Response to Comments for the Federal Register Notice for the Texas and Oklahoma Regional Haze State Implementation Plans; Interstate Visibility Transport State Implementation Plan to Address Pollution Affecting Visibility and Regional Haze; and Federal Implementation Plan for Regional Haze

Docket No. EPA-R06-OAR-2014-0754

12/9/2015

Quarterly and Annual SO₂ Emissions from Luminant Units Proposed by EPA for Further Controls (Table 11 and Figure 9 provided by Luminant (0061))

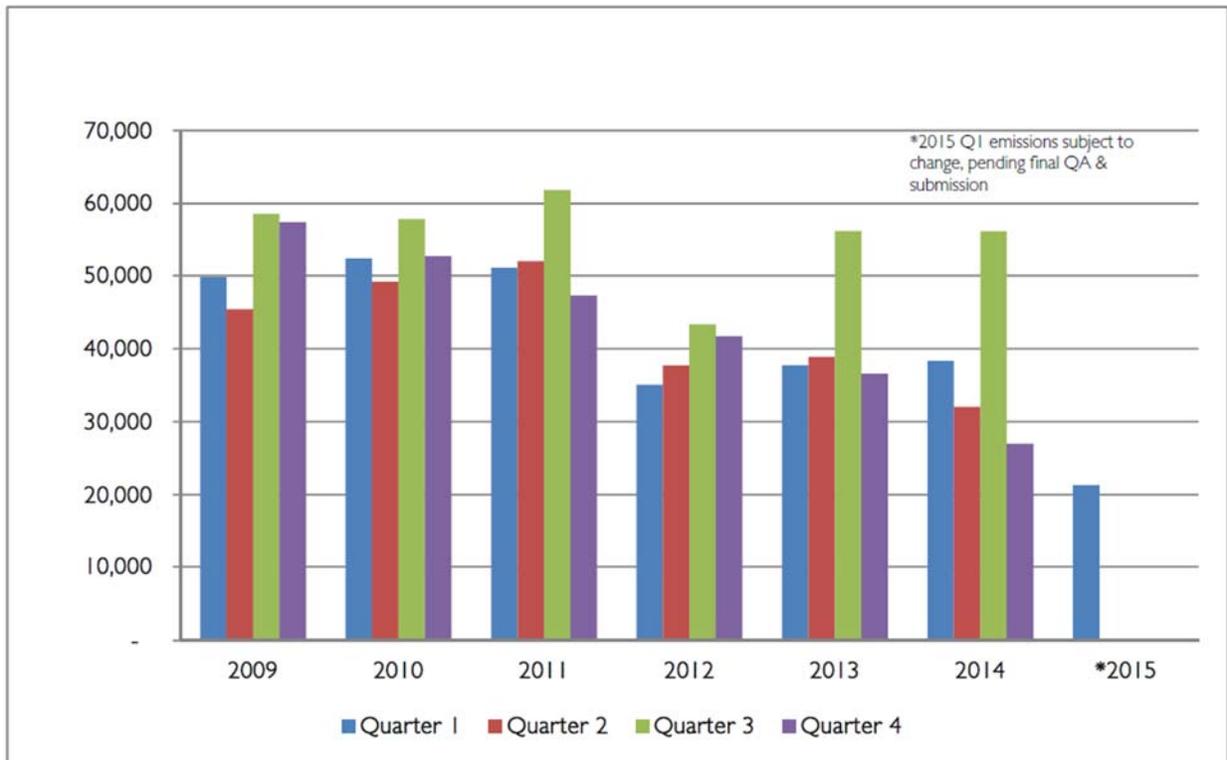
(Table 11 and Figure 9 provided by Luminant (0061)) shows the quarterly and annual SO₂ emissions for these units from 2009 to 2014, as well as the first quarter of 2015.⁶³³

Luminant noted that first quarter 2015 SO₂ emissions are sharply lower—approximately 57% lower than the first quarter of 2009 and about 44% lower than the first quarter of 2014. Again, the data unequivocally show that SO₂ emissions are trending down, and thus there is no basis for EPA’s proposal. These data also underscore the arbitrary nature of EPA’s approach of adjusting ENVIRON’s modeling based on three years of “actual” emissions from 2009 to 2013.⁶³⁴ As explained by Sargent and Lundy in its report prepared in support of Luminant’s comments, EPA’s selective use of data significantly understates the cost-effectiveness (that is, understates the cost per ton of SO₂ removed) and overstates the estimated benefits that EPA relies on for its

We disagree with the commenter that our adjusted actual emissions do not reflect the actual emissions at these units, as shown in Table 11 and Figure 9 of the Luminant comments. We used actual annual emissions taking a three year average of emissions from 2009-2013, excluding the maximum and minimum years. Table 11 and Figure 9 show emissions from this same period and more recent data but break up annual emissions into quarters and combine emissions across all Luminant units with proposed controls. We note that 3rd quarter SO₂ emissions are roughly constant from 2009-2014 and this period is typically when high sulfate impact days are observed. We used the most recent complete data that was available at the time we developed our analysis, 2009-2013, and excluded the max and minimum years to get a reasonable estimate of typical actual emissions. We provide additional information on recent emissions data from these sources in a separate response to comment.

EPA Proposed URP Glide Path for GUMO to 2018 and a Linear Regression Based on IMPROVE Observations (AECOM (0061/0075) Figure 2-7)

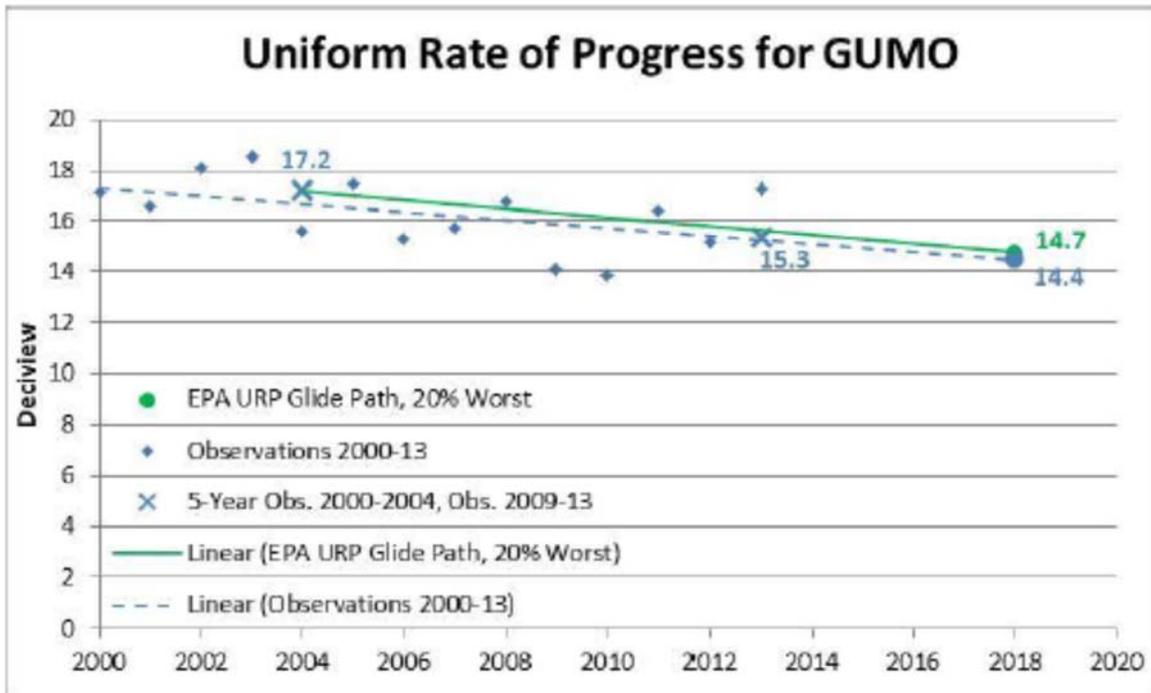
AECOM Figures 2-6 through 2-8 show the same IMPROVE data as compared to EPA’s approved URP for WIMO and its proposed URPs for BIBE and GUMO. With respect to the URP and its associated glide path, WIMO and GUMO indicate they are currently measuring conditions below the uniform glide path (green line). EPA recognizes this progress is greater than anticipated by the CENRAP modeling performed in support of the regional haze SIP.⁴³ BIBE does not indicate it is currently measuring below the uniform glide path; however, BIBE’s default natural conditions do not wholly represent the real impact of natural causes of hazy conditions. Further, given the projected emission trends shown in AECOM Figure 2-2, a linear regression⁴⁴ of the annual IMPROVE observations (dashed blue line) can be used to show the actual and projected rate of improvement for the 20% worst visibility conditions. Projecting this observation-based regression to 2018, the data clearly show that both WIMO and GUMO are on

**Observed and predicted W20% haze index values for Guadalupe Mountains.
(Figure 3 of Alpine (0078))**

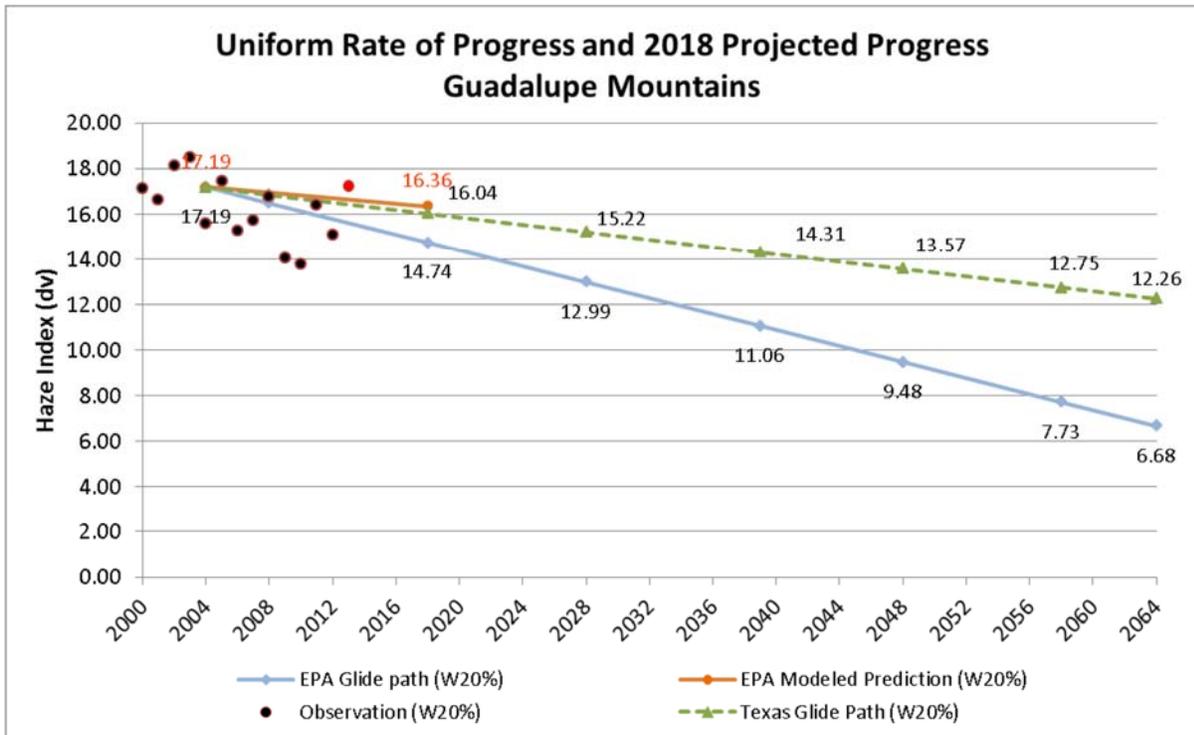
Alpine provided Figures 2 through 4 in Alpine comment 0078, showing these impacted W20% observation calculations are highlighted as red dots in 2011 and 2013.

Shown in Table 1 and Figures 2 through 4 of comment 0078, recent observations (black dots in Figures 1, 2, and 3) from these Class I areas indicate significant progress during the W20% days

Wildfire impact adjusted W20% haze index values for Big Bend National Park. (Figure 9 of Alpine (0078))

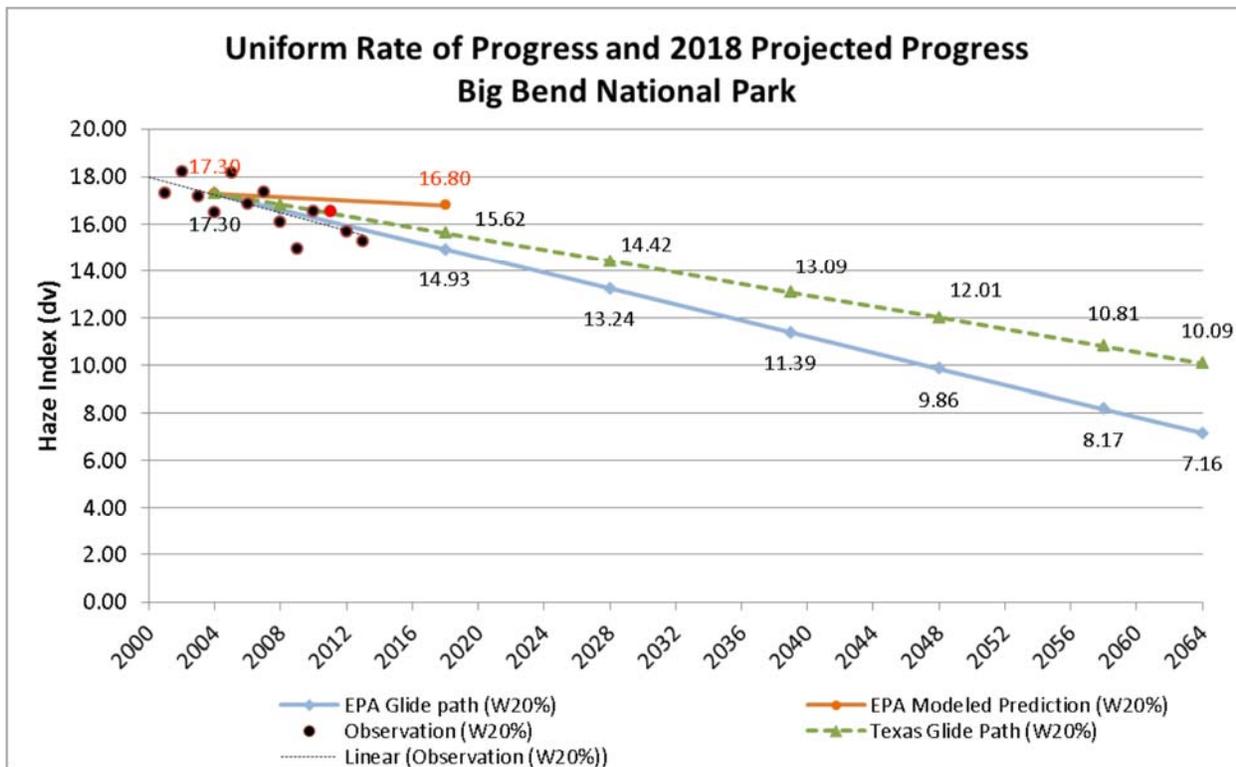
Alpine stated that when these wildfire impact days are removed from the W20% calculation, it can be seen in Alpine Figure 9 that the observational trend line would fall well below the EPA uniform rate of progress line.

Dust impact adjusted W20% haze index values for Guadalupe Mountains. (Figure 12 of Alpine (0078))

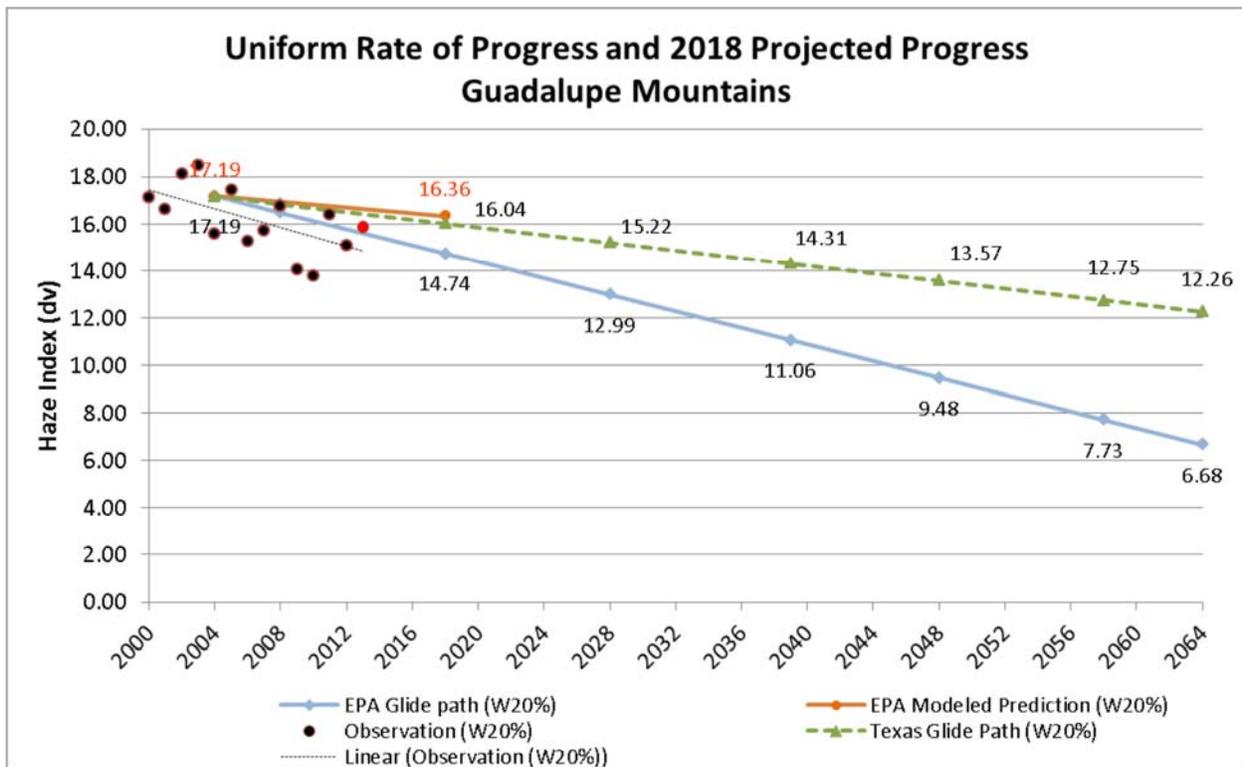
Alpine stated that in 2013 as documented in other years, dust event impacts have been tied to daily observations Class I areas in Texas.⁴ When removing dust impacted days from the W20% calculations, there are visibility trend improvement results comparable to years when wildfire impacts are removed, as shown in Alpine Table 4 and Figures 9 and 12 of comment 0078).

Alpine reviewed Satellite Smoke Text Product for each of the W20% days at Guadalupe Mountain for dust impacted periods identified in Alpine Table 4. Further satellite imagery of the domain was also collected from the NASA earth observatory website, corroborating the textual descriptions of most of the dust events. Alpine provided example images (Figure 11 of Alpine comment 0078, not reproduced here).
